**RE: Clancy Street Food Court
Response to Staff Comments; NPV# 97201**

Staff Discussion/Comments from April 17, 2024 Staff Report

Attachment A
Revised Site Plans
April 18, 2024

LIG-1

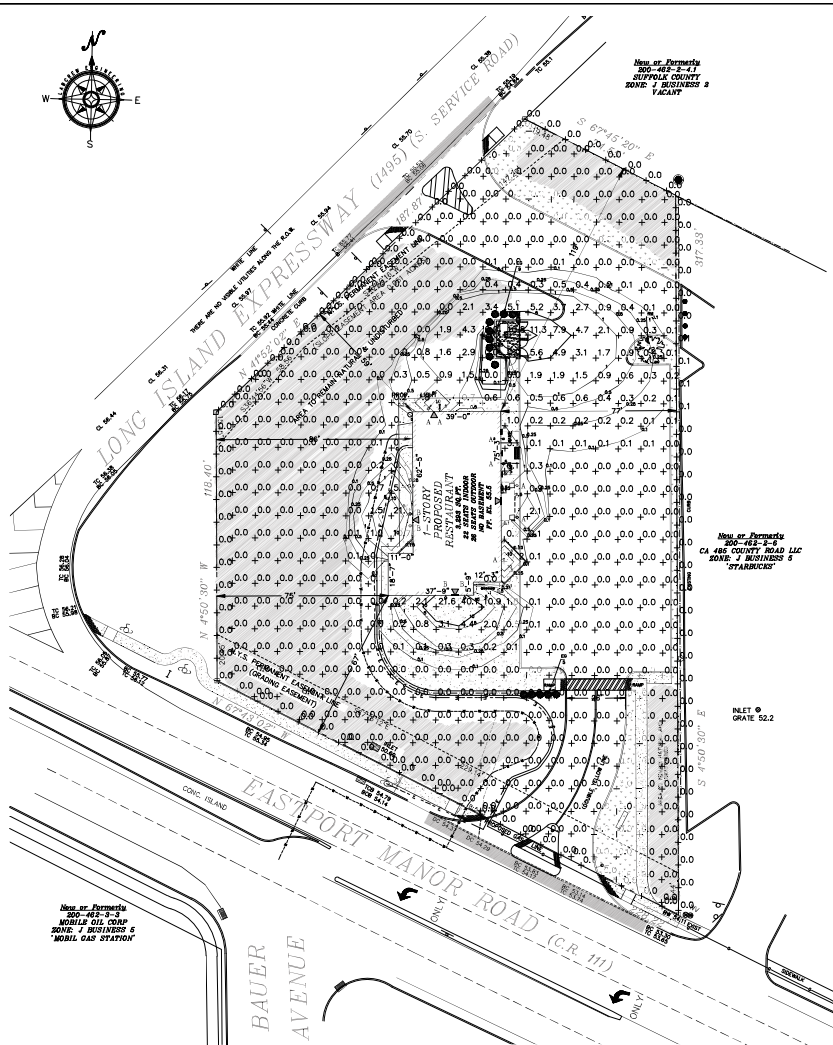
4. *Protect the character of the Central Pine Barrens*
 - a. *Protect existing large trees and other natural vegetation to maintain the character of the region and to provide a visual and noise buffer and screening from adjacent roads including for the outdoor seating area.*
 - b. *Signage should be minimal and consistent with the pine barrens landscape.*
 - c. *No signage variances should be granted.*
 - d. *Dark skies lighting fixtures should be in the site plan.*

Signage will be minimal and consistent with the pine barrens landscape (see signage detail in **Attachment B** and rendering depicting signage in **Attachment C**). No signage variances will be sought. A design of the signage is representative in the architectural design plan and has been submitted for review. The project will meet Town Code for dark sky compliance (see Plan Sheet LIG-1 in **Attachment A**).

sheet no.
A-1

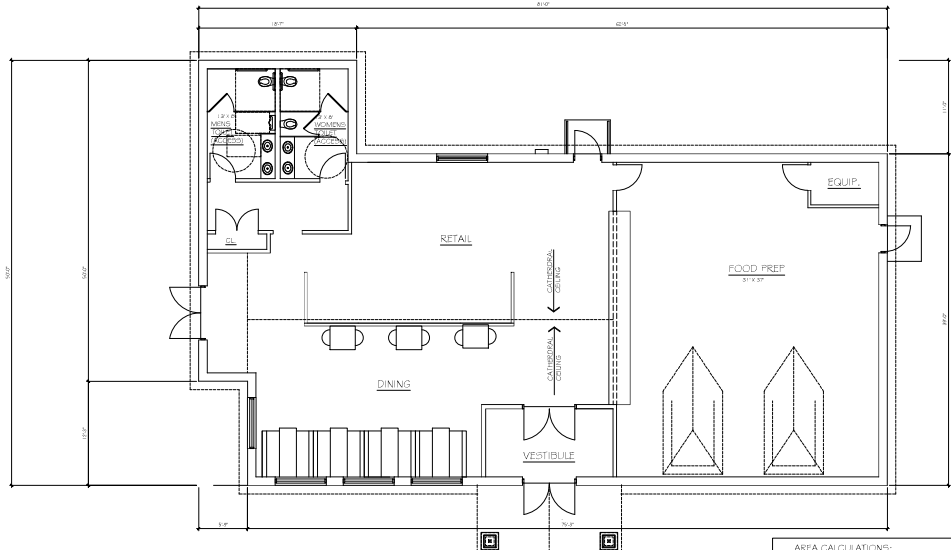
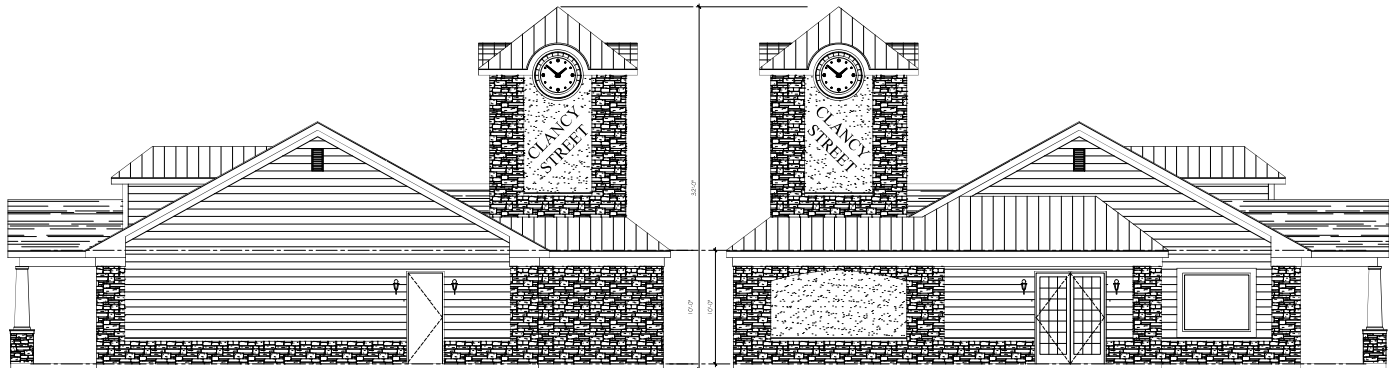
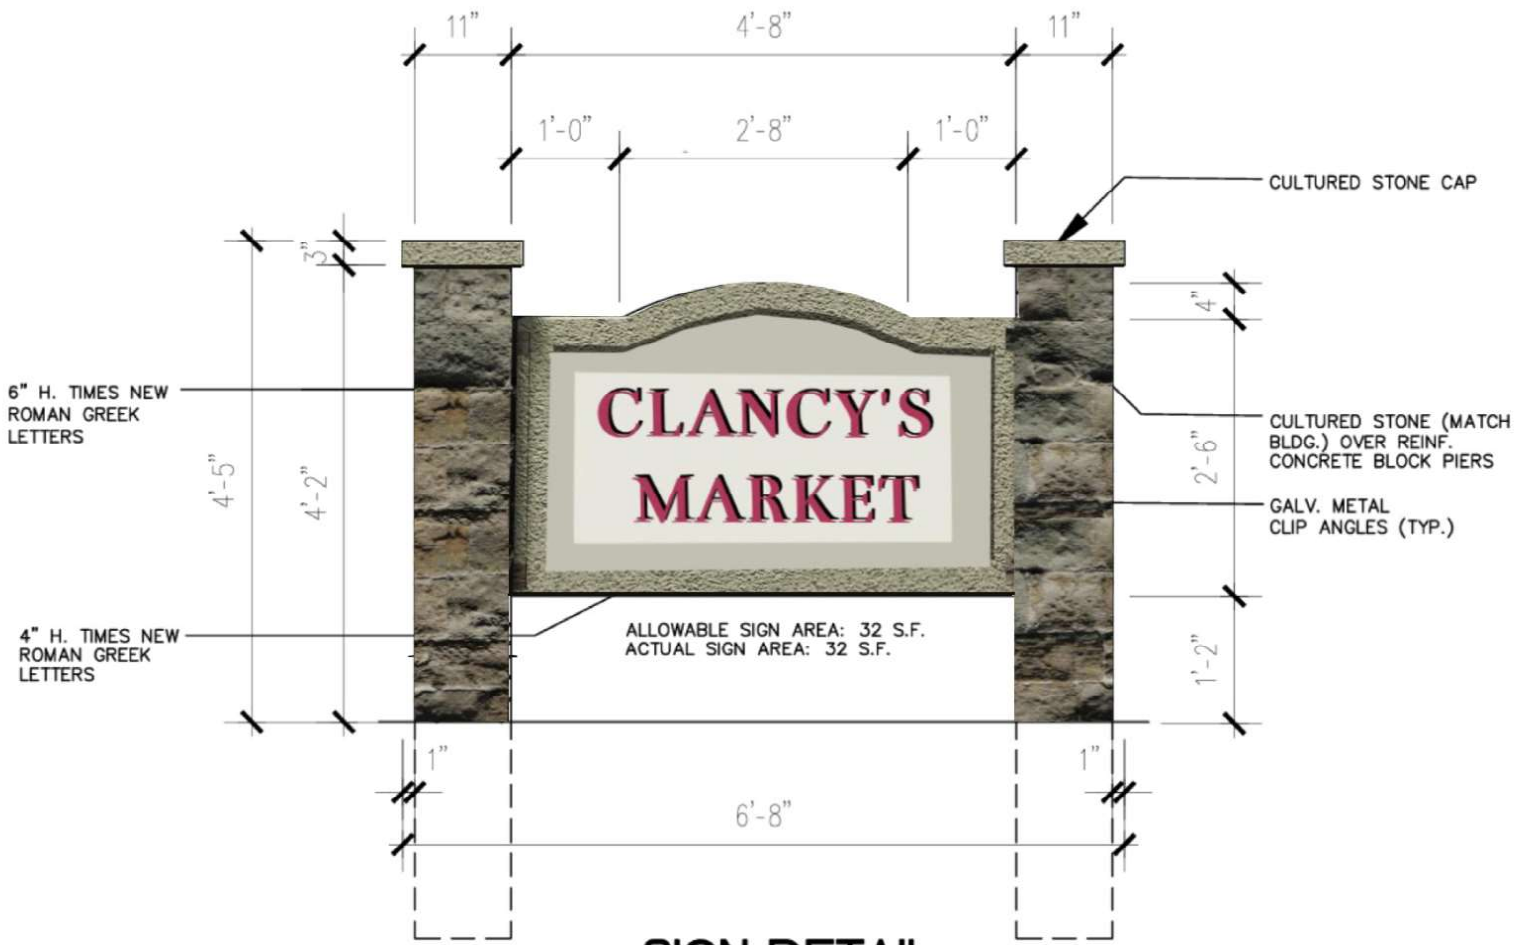
- 1. The Core is a sending not receiving area for Pine Barrens Credits (PBCs). The proposal seeks to redeem 1.2 PBCs in the Core. This proposal contradicts the Comprehensive Land Use Plan and the goals and objectives of the Act. The Plan, Section 6.4.2.1 Brookhaven Pine Barrens Credit Program overview, explains the Pine Barrens Credit Program for the Town of Brookhaven is designed to redirect development for residentially zoned lands within the Core Preservation Area to receiving districts throughout the Town.*

The applicant was directed through the Health Department to purchase land for preservation in the same watershed. The applicant for the project should consult with the Health Department in this matter. Other options may include reducing the number of restaurant seats to conform.

The Applicant has agreed to reduce the number of restaurant seats so the purchase of a Pine Barrens credit is not required to accommodate the reduced sanitary flow. A revised plan has been provided (see **Attachment A**). Per the revised plan, the number of proposed restaurant seats has been reduced from 54 indoor seats and 32 seasonal outdoor seats to 22 indoor seats and 26 outdoor seasonal seats.
